From: [Mya Starling](#)
To: [Board of Public Works](#)
Subject: 19 Nov Board of Public Works Meeting Agenda Item 90845. Handout for Public Comment
Date: Wednesday, November 19, 2025 1:17:37 AM
Attachments: [Pontiac Trail Before And After.docx](#)

From: [Layne Larson](#)
To: [Board of Public Works](#)
Subject: Public Comments and Exhibits - Pontiac Trail - Agenda Item 5 - Pontiac Trail
Date: Tuesday, November 18, 2025 1:36:27 PM
Attachments: [Option 1 vs 3 Summary.pdf](#)
[Pontiac Trail - Option 3 Public Comment.pdf](#)
[Pontiac Trail Exhibits -- 11-18-2025B Exhibit.pdf](#)

Pontiac, Boston, Nokomis, and Rosewood Reconstruction

901 Pontiac Trail

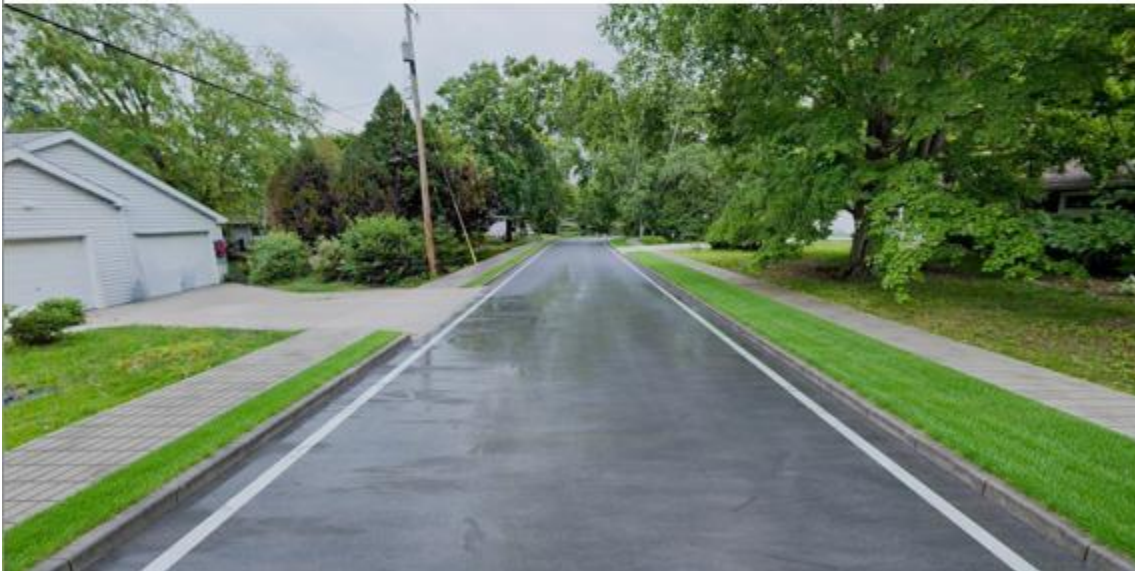
These are renderings to illustrate the impact of this project on the character of Pontiac Trail, the loss of canopy, and the change of the look and feel of the neighborhood.

Using Google Maps and superimposing the Proposed Street Design Option 1, conservatively estimating that the existing road is 22 feet wide in all places (it varies between 20 and 22 feet), adding 2 feet of road width, 6 inches of curb, 5 feet of sidewalk and the width of road verge varying as indicated in the Proposed Street Design Option 1. Trees were removed as indicated in the Option 1 Proposed Street Design, as well as where their location was incompatible with planned sidewalk placement. Removal of canopy was limited to known tree removal in the immediate background; distant canopy was not addressed. Therefore, canopy removal was conservative.

Figure 1 - South Segment - Sidewalk on both Sides due to higher density apartments

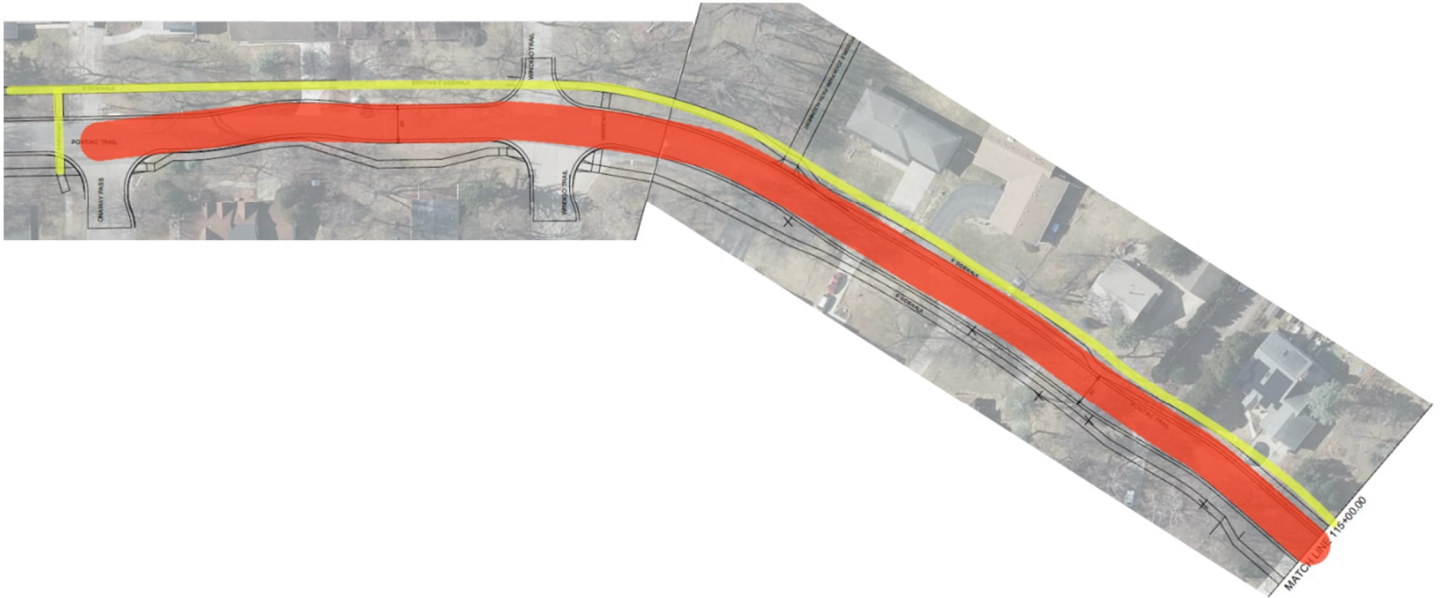
- Sidewalks on both sides of Pontiac Trail in the South segment, where residential density is higher.
- Sidewalks on the west side only in the Middle and North segments, preserving green space, canopy trees, and the historic character of Summit Woods.
- Accessible crosswalks at Onaway Pass and Mohican Pass to ensure safe pedestrian movement across the street.

Exhibit A -- Overbuilt Design Contradicts Green Streets Principles

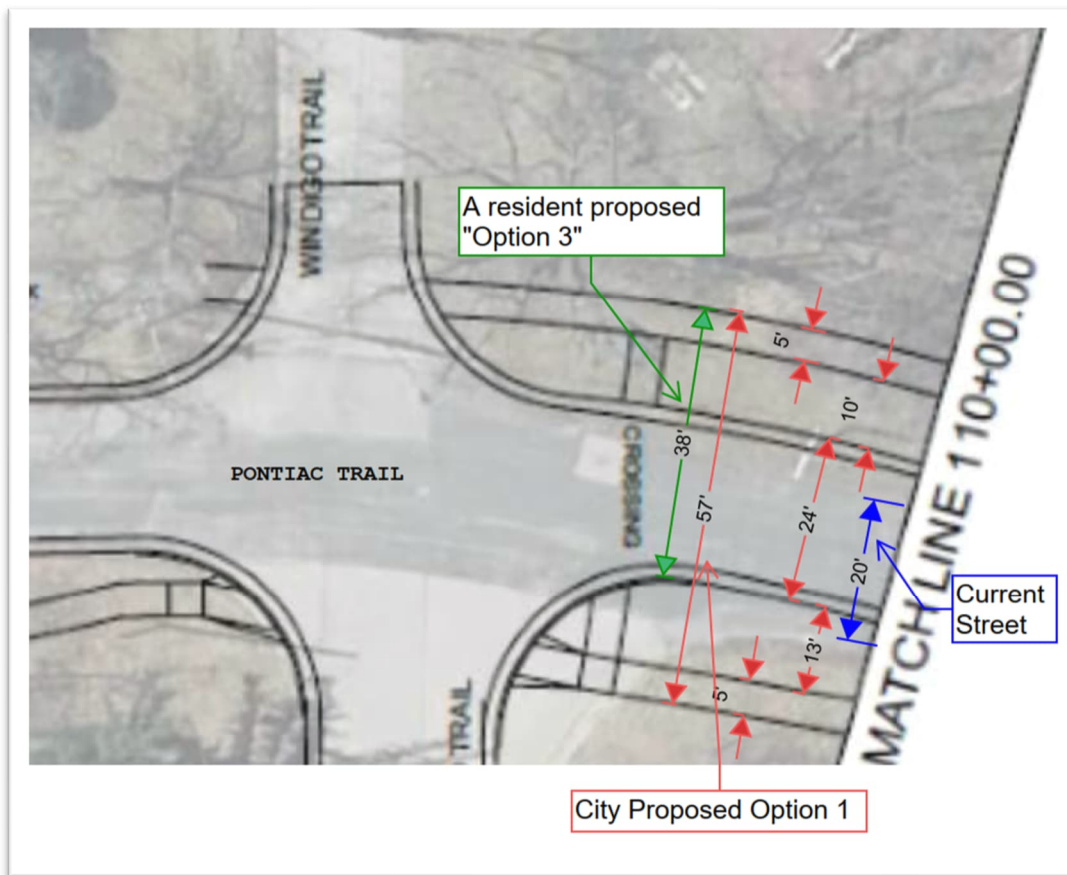
The Guide is explicit: “There is no one design of a Complete Street.” A cross section nearly three times wider than the existing does not reflect that context-first approach. “Streets should be designed for today’s needs, with additional right of way reserved for the future if needed.” (Page 7 GSG)

The new design is almost 3x wider than the current street!

Is this design truly responsive to neighborhood scale and character? Does it reflect the Guide’s call for restraint, balance, and environmental sensitivity?

Accessibility Issue 2 – Double Street Crossing from Zook Park to the Southwest Path

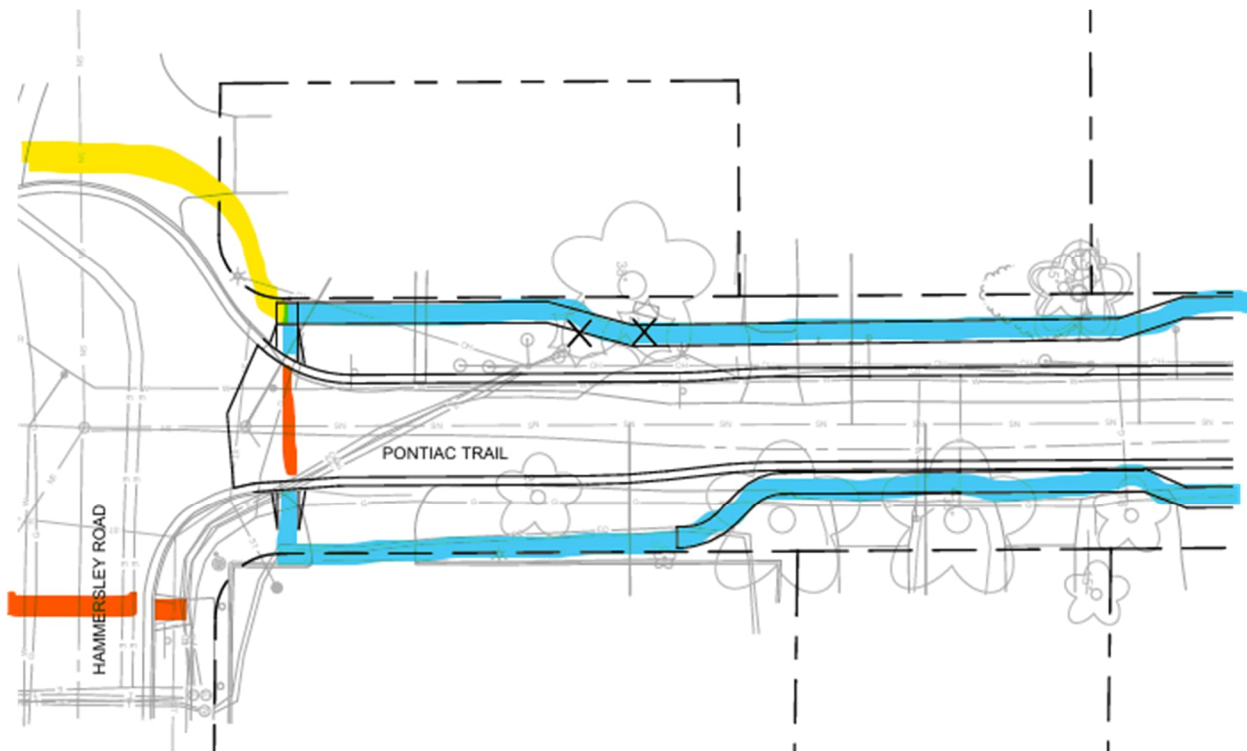
The most useful route along Pontiac Trail would be to connect Zook Park with the Southwest path. The current design doesn't do that without requiring pedestrians to cross the street twice. This raises a critical question: why will this not be addressed? Forcing multiple crossings adds unnecessary complexity and risk, particularly for users with disabilities.

Red Highlights: The current design requires two street crossings to travel from the Southwest Path to Zook Park. An unnecessary burden for residents with mobility or vision challenges. Blue Highlights: Proposed and existing sidewalk segments. Yellow Highlight: Route to Southwest Path.
